CODE CHANGES RESOURCE COLLECTION: 2009 IFC[®]

APPROVED CODE CHANGES RESULTING IN THE 2009 IFC[®]

The following details are taken from the above referenced ICC and ICBO publications.

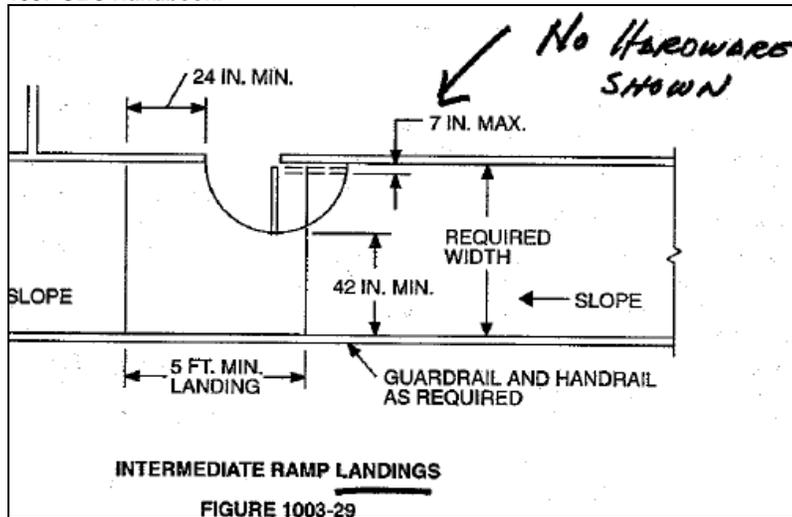
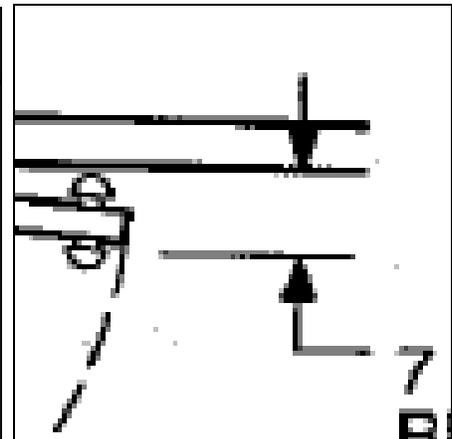
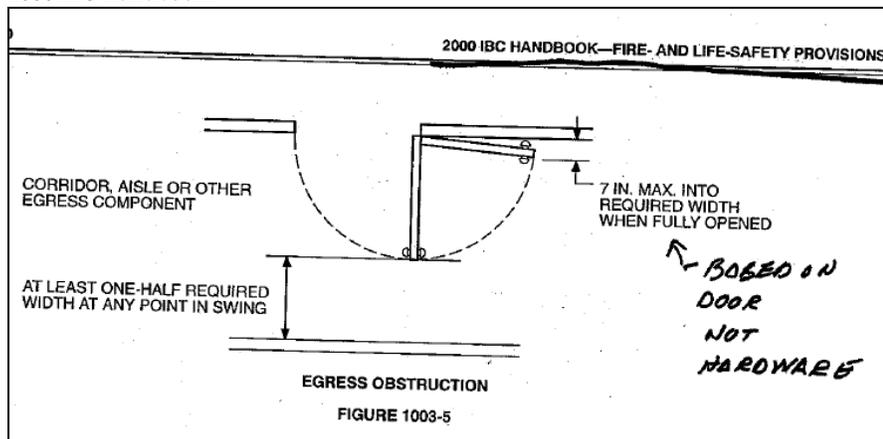
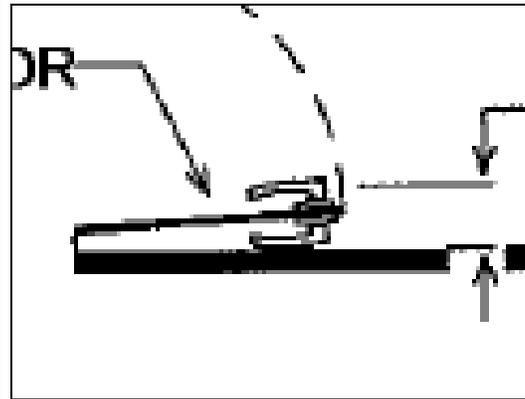
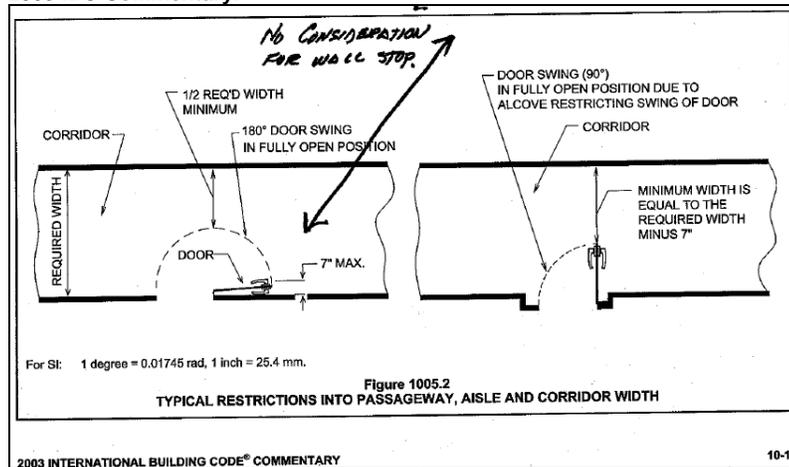
The best illustration of just how confusing the current text is, and the best justification for this needed clarification, are the ICC Commentaries. The 7" door encroachment requirement is based upon legacy code provisions and has survived intact. In the *1997 UBC Handbook*, figure 1003-29 provides a detail with a dimension indicating a maximum of 7" door encroachment, but the figure shows no hardware and the dimension line leads to the edge of the door surface. Fast-forward to the 2000 *IBC Handbook Fire and Life-safety Provisions* and to figure 1003-5. In this detail, hardware has been added to the illustration but the 7" dimension line has moved to some vague point between the door slab and the doorknob. In the 2003 *IBC Commentary* Figure 1005.2, the detail has been modified to show accessible hardware instead of a doorknob, but the dimension line again leads to some vague spot on the door latch.

Despite the fact that the technical provision for door encroachment has not changed since the legacy codes, ICC artists have arbitrarily changed the details in the commentaries. The clarification provided by this proposal is necessary to clean up the ambiguity and resolve the issue in order to facilitate consistent code interpretations. The proposal is not a change in the requirement, merely a clarification made necessary by the confusion created by the ICC commentaries.

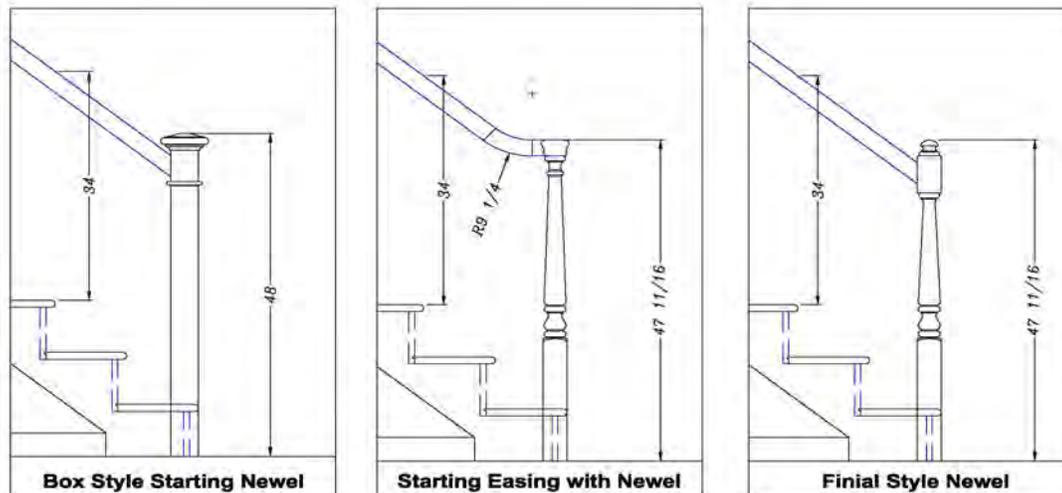
Reason: The proposed change will make editorial corrections required as well as clarify the use of newels

The need to allow the use of a newel at intersections of the rail in dwelling units at a turn in the stair to provide for the use of newels within a flight has been recognized and allowed within the IRC and should be included in the IBC to allow lower cost options that have not caused any known attributable safety issues.

1. Handrails within dwelling units are permitted to be interrupted by a newel post at a turn stair landing.
2. Within a dwelling unit, the use of a volute, turnout, ~~or~~ starting easing or starting newel is allowed ~~on~~ over the lowest tread.
3. Handrail brackets or balusters attached to the bottom surface of the handrail that do not project horizontally beyond the sides of the handrail within 1.5 inches (38 mm) of the bottom of the handrail shall not be considered obstructions. For each 0.5 inch (12.7 mm) of additional handrail perimeter dimension above 4 inches (102 mm), the vertical clearance dimension of 1.5 inches (38 mm) shall be permitted to be reduced by 0.125 inch (3 mm).

Diagram 1 – TYPICAL WALL SECTIONS AT STAIRS IN PLAN VIEW

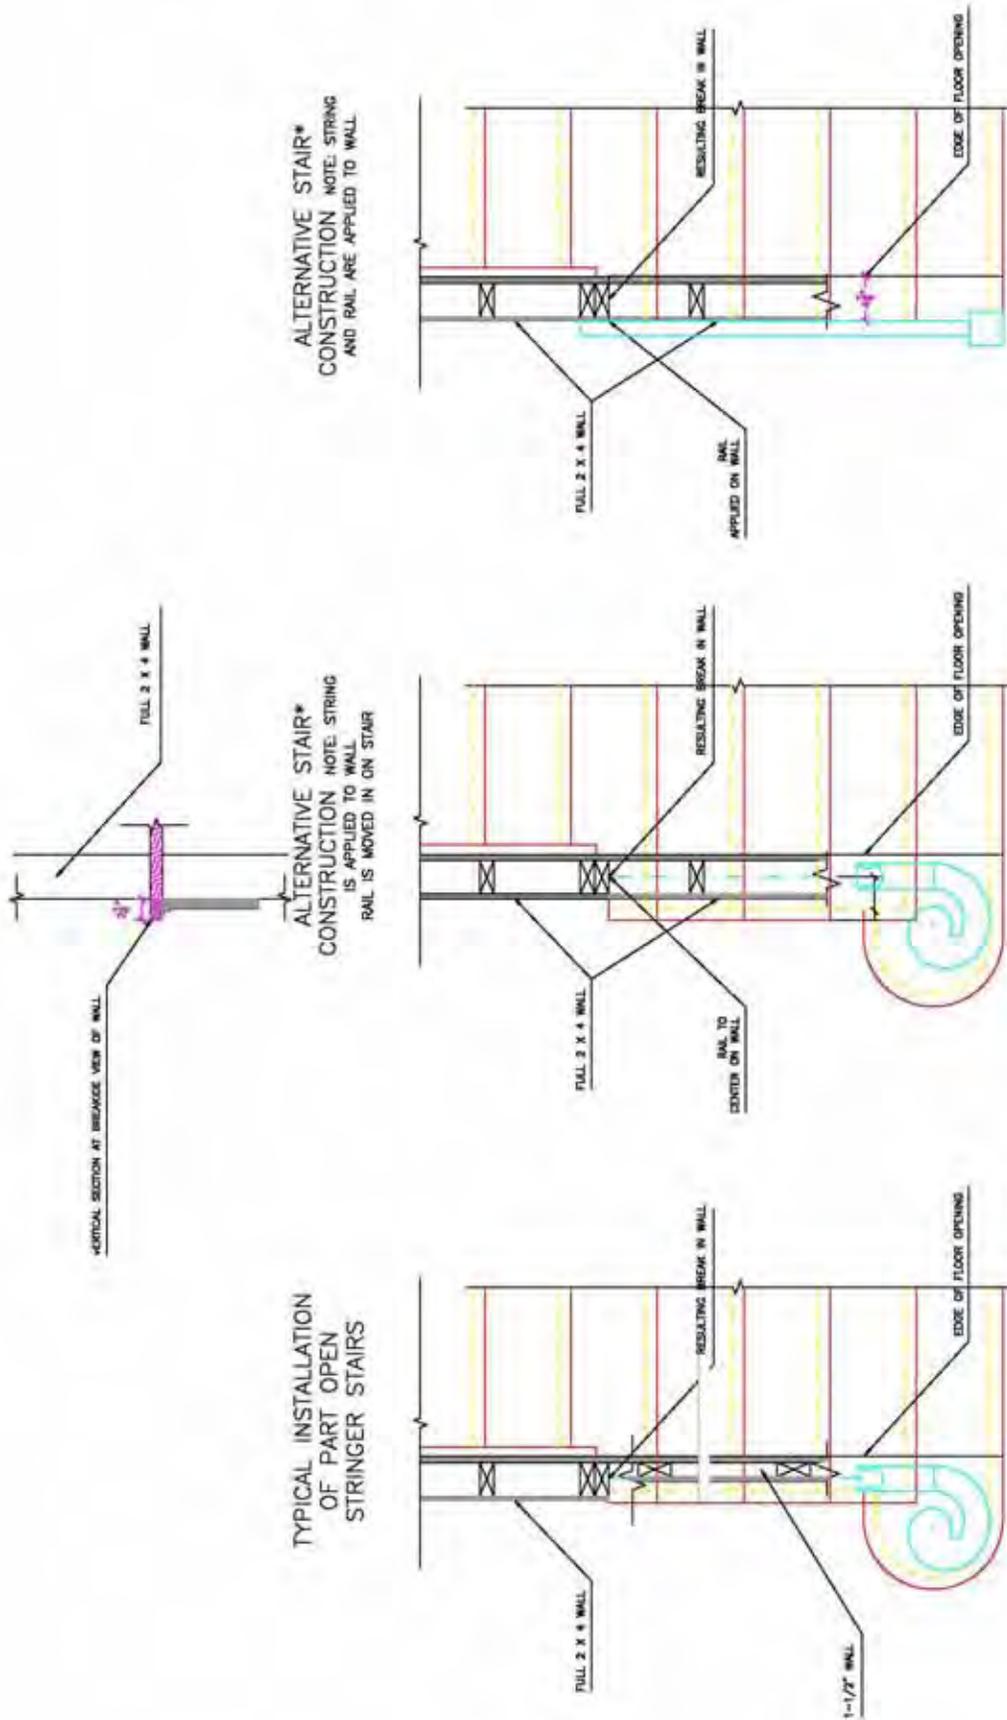
R311.5.2 Headroom. The minimum headroom in all parts of the stairway shall not be less than 6 feet 8 inches (2036 mm) measured vertically from the sloped plane adjoining the tread nosing or from the floor surface of the landing or platform on that portion of the stairway that is available for placement of the foot in ascent or descent.

Figures 1, 2, & 3 show common walk line locations as determined by the modification. The walk line, balusters, post, and tread nosings are in black. The wall is green and the skirt board or finish stringer is in red.

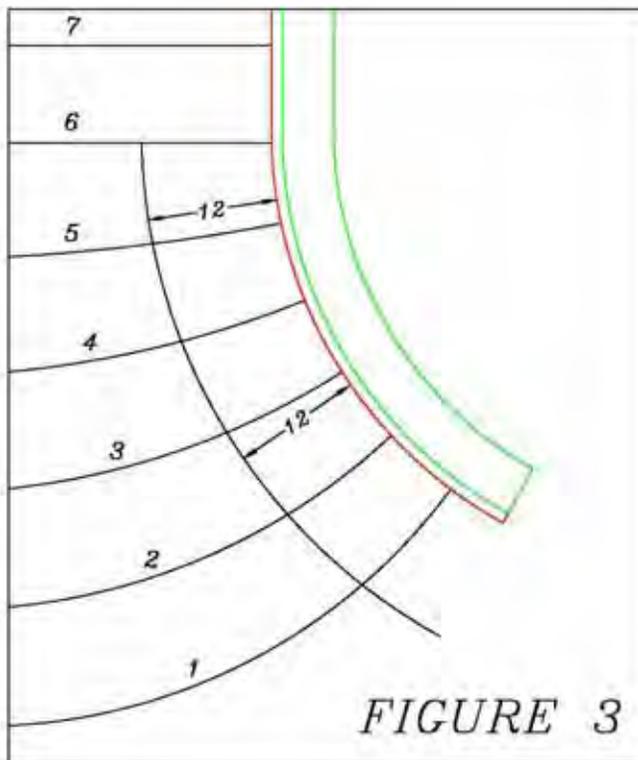
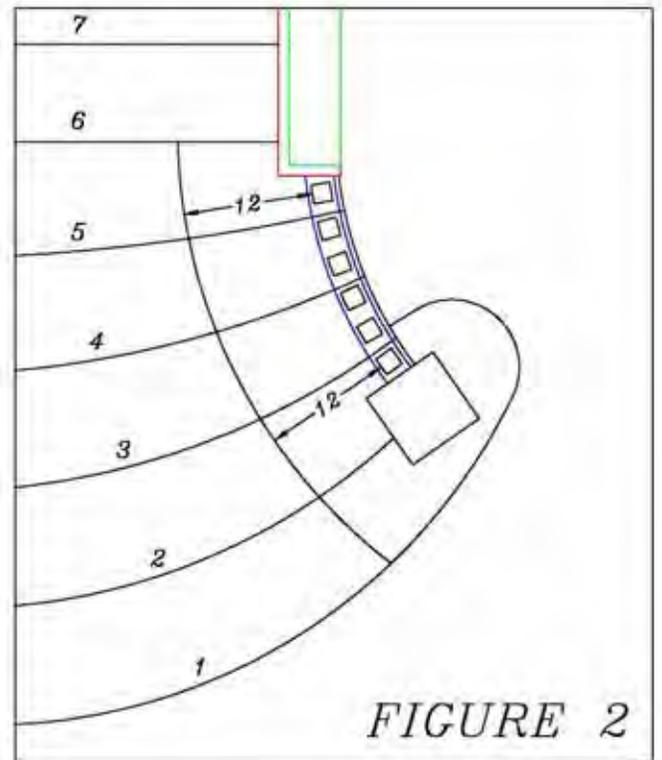
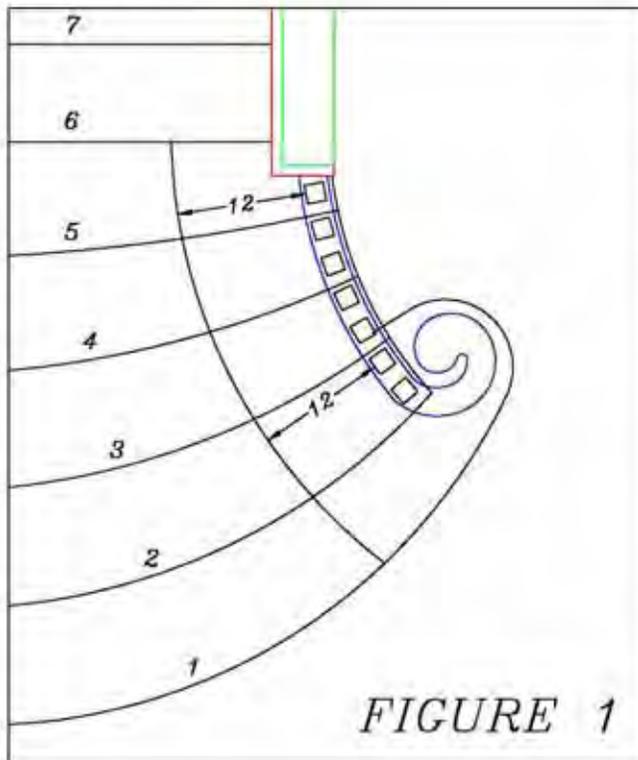
The IRC committee had issues with the terminology "used for placement of the foot..." and that has been stricken. The new section titled walk line states clearly and specifically how to locate the walk line at winder treads where it is used to determine the tread depth of winder tread(s) that provide for turning of the stair's direction of travel. This line of travel across winders is a curved path and the walk line established for regulation must parallel it. The term concentric is used because it more accurately describes the geometry of parallel arcs or curves sharing the same center. This separate section substantiates this essential element required in the design and construction of stairs that turn. It further provides clarity for regulating its location that is not subject to the wide interpretation of the present code and thereby allows for the direct reference to walk line in subsequent sections of the code. Please also see the original supporting statement for further substantiation of these changes.

Locate the winder treads in the turn of the stair.

1. Locate the side of the stair where the winder treads are narrower
2. Establish the widest point of clear width of the stair at the surface of the winder or run of adjacent winders
3. Measure across the stair width 12 inches from the object that restricts the clear width at the tread surface
4. Measure tread depth between the intersections of the nosings with the walk line.

R311.5.2.3 Walk line. ~~The walk line is the line of travel used to provide for uniform layout of the tread depths in the design and regulation of flights with winder treads. The walk line shall be parallel to the side of the flight where the treads are narrowest and located 12 inches (305 mm) from the point of minimum tread depth used for placement of the foot on the flight in ascent or descent. The walk line across winder treads shall be concentric to the curved direction of travel through the turn and located 12 inches (305 mm) from the side where the winders are narrower. The 12 inch (305 mm) dimension shall be measured from the widest point of the clear stair width at the walking surface of the winder. If winders are adjacent within the flight, the point of the widest clear stair width of the adjacent winders shall be used.~~

R311.5.3.2 Tread depth. The minimum tread depth shall be 10 inches (254 mm). The tread depth shall be measured horizontally between the vertical planes of the foremost projection of adjacent treads and at a right angle to the tread's leading edge. The greatest tread depth within any flight of stairs shall not exceed the smallest by more than 3/8 inch (9.5 mm). Winder treads shall have a minimum tread depth of 10 inches (254 mm) measured between the vertical planes of the foremost projection of adjacent treads at the intersections with the walk line. Winder treads shall have a minimum tread depth ~~used for placement of the foot ascent or descent~~ of 6 inches (152 mm) at any point within the clear width of the stair. Within any flight of stairs, the largest winder tread depth at the walk line shall not exceed the smallest winder tread by more than 3/8 inch (9.5 mm).

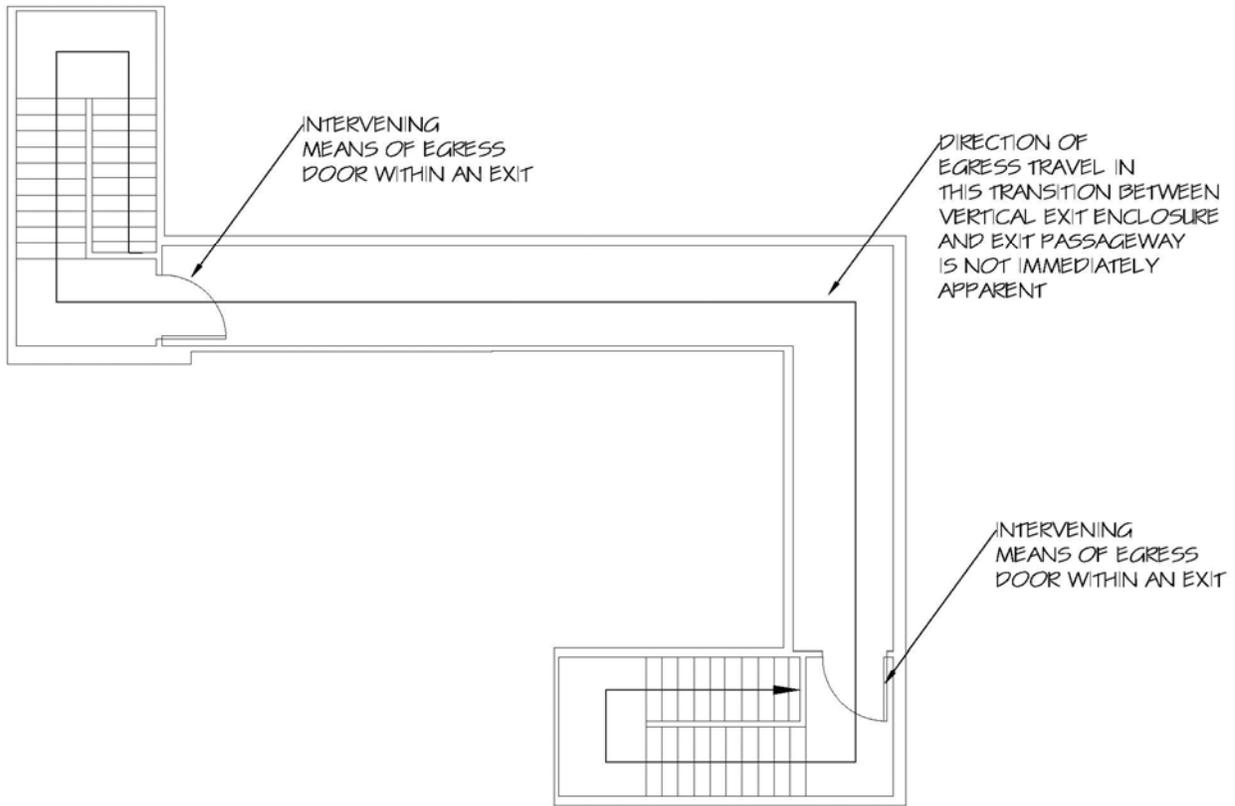
Reason: Section 1011.1 requires exit signs along the exit access to help occupants to reach the exits. Typically, once the occupants reach the exits, exit signs are not required within the exits. However, in buildings with more complicated egress layout, it is possible that the direction of egress travel within the exits may not be immediately apparent to the occupants. For example, a vertical exit enclosure on the north side of a building may transition into a horizontal extension in the form of either an extended landing/corridor or an exit passageway with intervening means of egress doors on the 15th floor before continuing down into the staircase on the south side. The path of egress might involve turns with extended distances. In such cases, it is important to provide clear egress direction for the occupants within the exits.

The report from the 2003 World Trade Center Building Code Task Force identified the problem of clarity or "readability" of travel within exit enclosures, and in response to the 1993 and 2001 World Trade Center incidents, recommended additional exit signs within the exit enclosures.

1. Exit signs are not required in rooms or areas that require only one exit or exit access.
2. Main exterior exit doors or gates that are obviously and clearly identifiable as exits need not have exit signs where approved by the building official.
3. Exit signs are not required in occupancies in Group U and individual sleeping units or dwelling units in Group R-1, R-2 or R-3.
4. Exit signs are not required in sleeping areas in occupancies in Group I-3.
5. In occupancies in Groups A-4 and A-5, exit signs are not required on the seating side of vomitories or openings into seating areas where exit signs are provided in the concourse that are readily apparent from the vomitories. Egress lighting is provided to identify each vomitory or opening within the seating area in an emergency.
